Addendum No. 3
Four Rivers Sanitation Authority
Collection Systems Operations Facility
Capital Project No. 2217

This Addendum No. 3, dated February 14, 2023, for the above referenced project, supersedes all contrary and conflicting information in the specifications and contract documents, which are hereby supplemented or revised as follows:

New Collection
Systems Operation
Facility

C303
PROFESSIONAL DESIGN FIRM REGISTRATION #

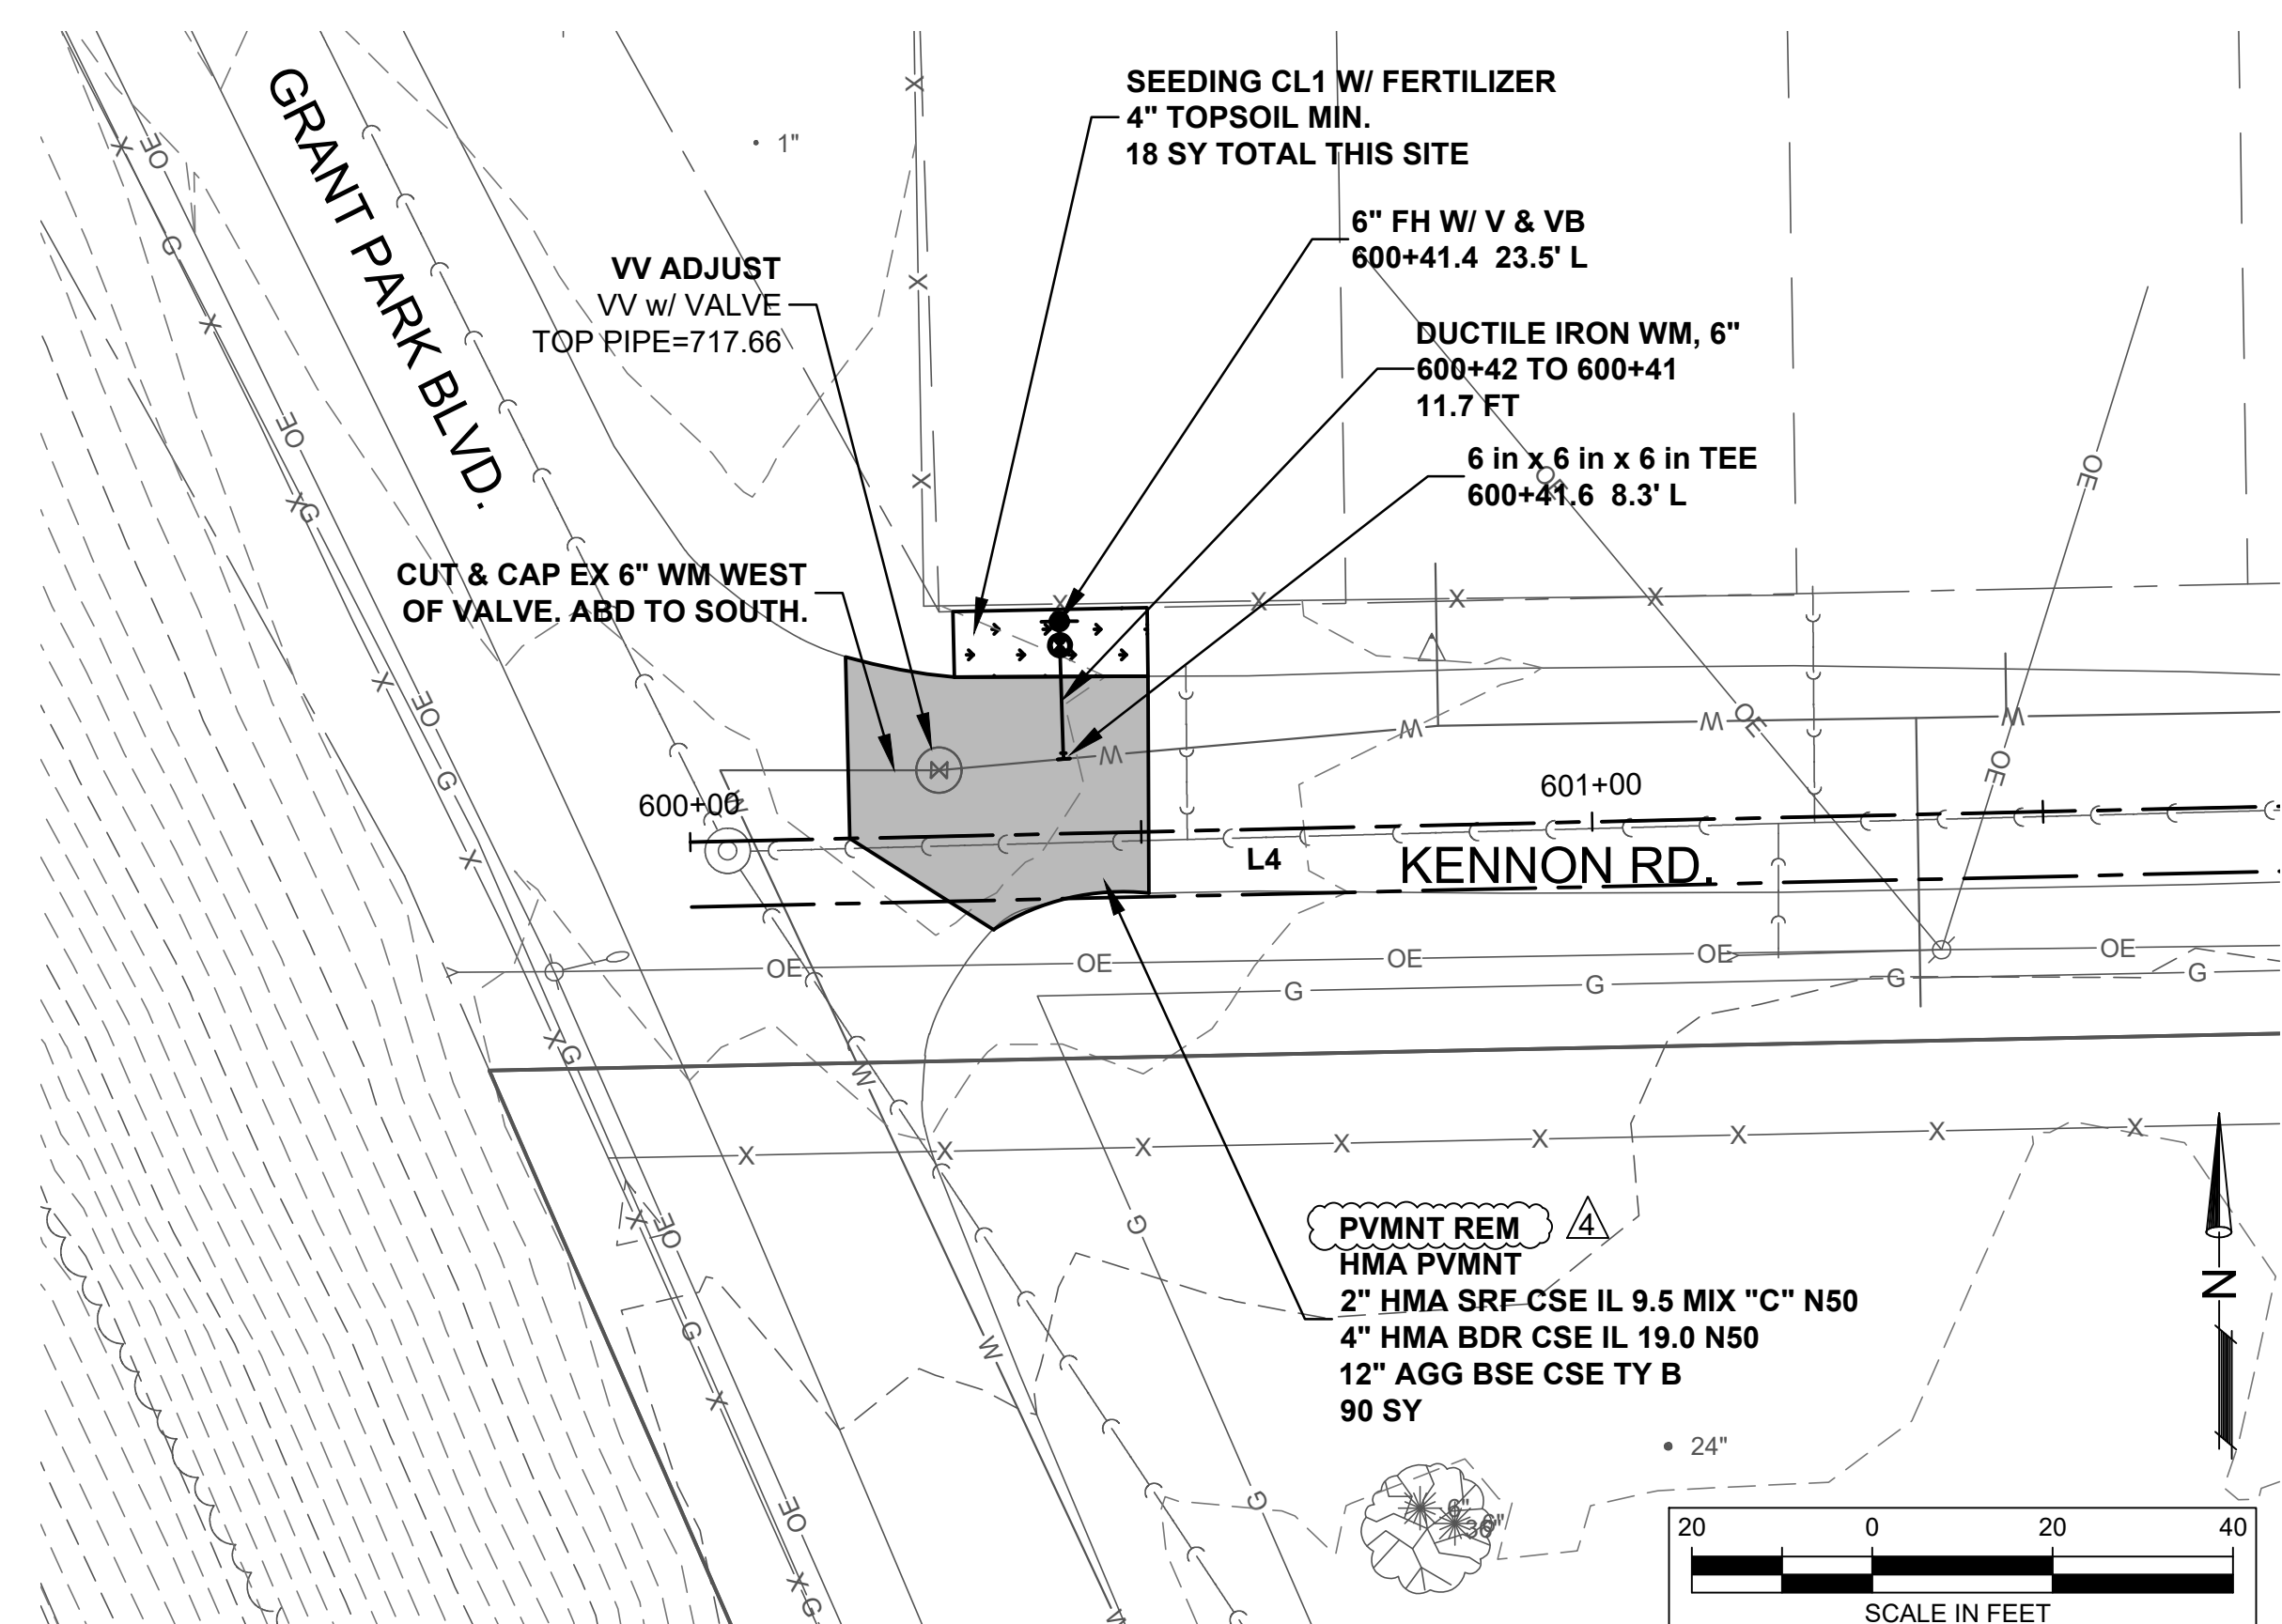
22. Removals for the Kennon Street hydrant and water main work are not indicated on Plan Sheet C101.

34. Is there any water main demo on Blair Street? What currently exists at the 8" to 6" reducer location?

Response: *Reference revised Plan Sheet C303 for removal limits.*

Response: *The Blair Street 6" dia. watermain exists as shown on Plan Sheet C303 – the proposed watermain fills in a gap. The Contractor shall cut a portion of the existing watermain off at Kennon Road to connect the new 8" to 6" reducer.*

Ref. North Sheet No.
ES103

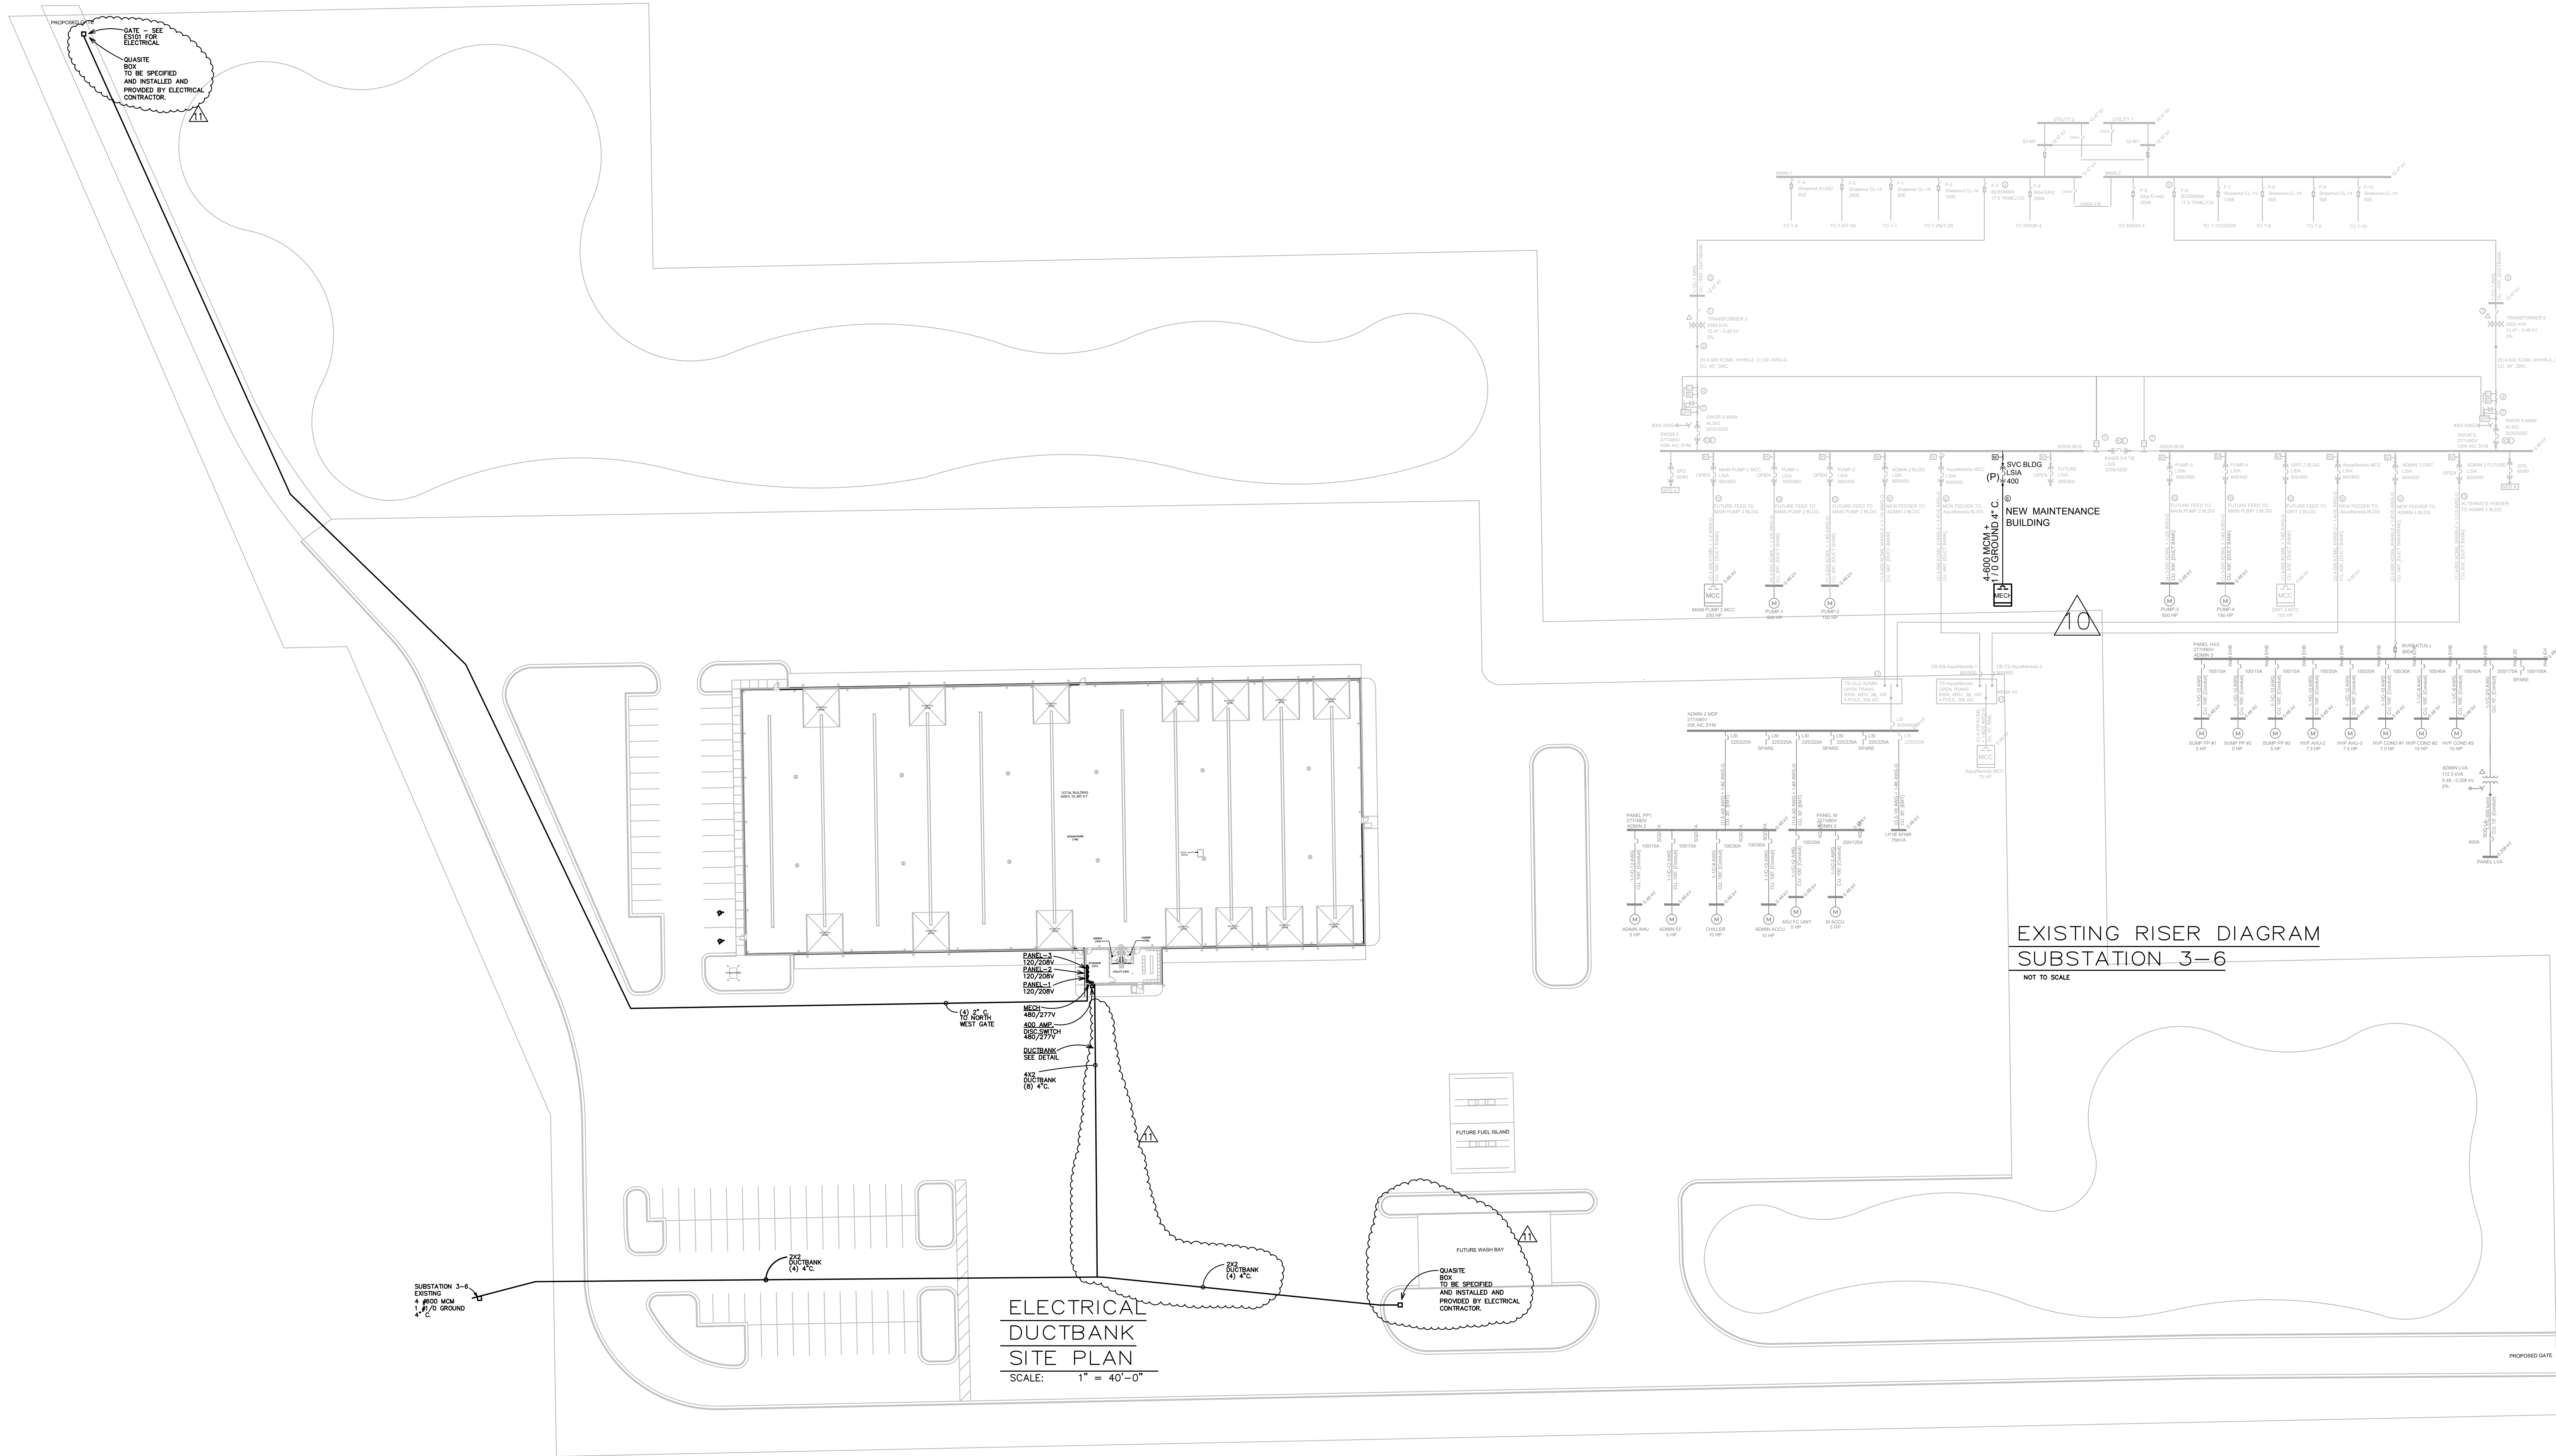
3. On Sheet ES103 do the four (4) 2" conduits to the North gate need to be in a duct bank?

4. On Sheet ES103 it shows four (4) 4" ducts going to the South quazite box. What is going to the North quazite box at the future wash bay?

5. On Sheet ES103, it shows a total of twelve (12) 4" pipes in the ductbank but after the split it appears that there only needs to be eight (8). Is this correct?

6. On Sheet ES103, for the ductbank and the four (4) 2" to the gate, where do we stub these up to, or where do we leave the end?

Response: *No, per the callout on Plan Sheet ES103 these conduits are to be direct buried. Reference revised Plan Sheet ES103.*

Response: *The north quazite box has been omitted from the plans, reference revised Plan Sheet ES103.*

Response: *Reference revised Plan Sheet ES103 for clarification.*

Response: *A quazite box has been added at this location, reference revised Plan Sheet ES103.*
